## Commission of Architectural Review

1. COA-173550-2025	Final Review Meeting Date: 10/28/2025
Applicant/Petitioner	Brian Spencer
Project Description	Enclose a rear porch on the second floor.
Project Location	
Address: 17 N Arthur Ashe Boulevard	
Historic District: Boulevard	
<p>High-Level Details:</p> <p>The application proposes enclosing the existing second-floor rear porch. The new enclosure will be clad in wood siding and include a skylight. The project also includes unearthing and restoring the previously infilled basement door and concrete stairway leading to grade. Repairs or in-kind replacement of the stairs will match the original material and dimensions.</p>	
Staff Recommendation	Approval, with Conditions
Staff Contact	Yara Iwaz, Yara.Iwaz@RVA.gov, (804)646-6031
Previous Reviews	In the July 2025 meeting, the commission approved an application to construct a new front porch
Staff Recommendations	<p>Staff recommends approval of the application, with the following conditions:</p> <ul style="list-style-type: none"> <li>• Approve the proposed enclosure; all construction to be done in a manner that minimizes damage to the historic fabric</li> <li>• Approve the proposed board-a

Figure 2: Infilled basement door

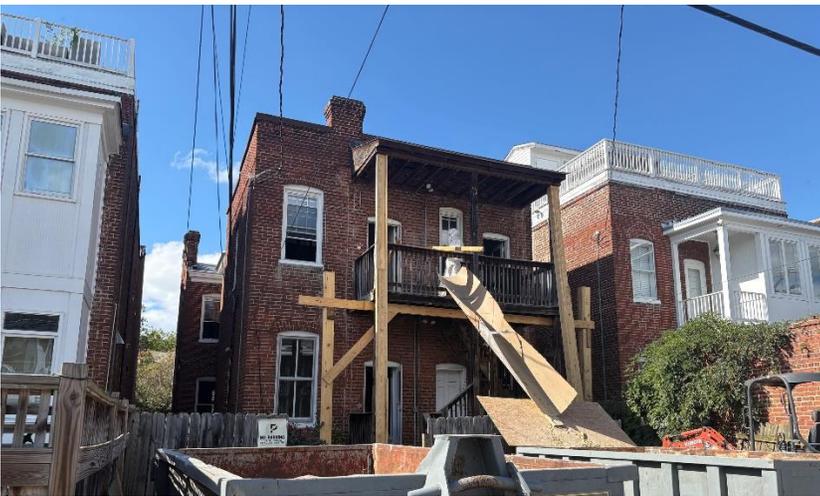
Building Elements, p.66	<i>4. New elements such as vents or skylights should not be added to the front façade of a roof. These elements should be located in roof areas hidden from primary views.</i>	<p>The new skylight will be located on the rear roof slope. While skylight features are not typically found in the historic district, this addition will be located at the rear of the building and not visible from Arthur Ashe Boulevard. It will also be minimally visible from the alley due to the roof's soft slope.</p> <p><u>Staff recommends approval of the skylight as proposed, ensuring it remains flush with the roof and minimally visible.</u></p>
Standards for Rehabilitation, p.5	<i>6. Deteriorated historic features shall be repaired rather than replaced. When the severity of deterioration requires replacement or a distinctive feature, the new feature shall match the old in design, color, texture and other visual qualities and, where possible, materials. Replacement of missing features shall be substantiated by documentary, physical or pictorial evidence.</i>	<p>The project will restore a previously infilled basement door and unearth a concrete stair. Any repair or replacement will be in-kind with matching dimensions and materials.</p> <p><u>Staff recommends approval of the restoration of the basement access. Final basement door design to be compatible with the existing building; details to be submitted for administrative review.</u></p> <p><u>Staff further recommends that all construction be undertaken using best preservation practices, ensuring the protection of historic fabric during excavation and masonry removal.</u></p>
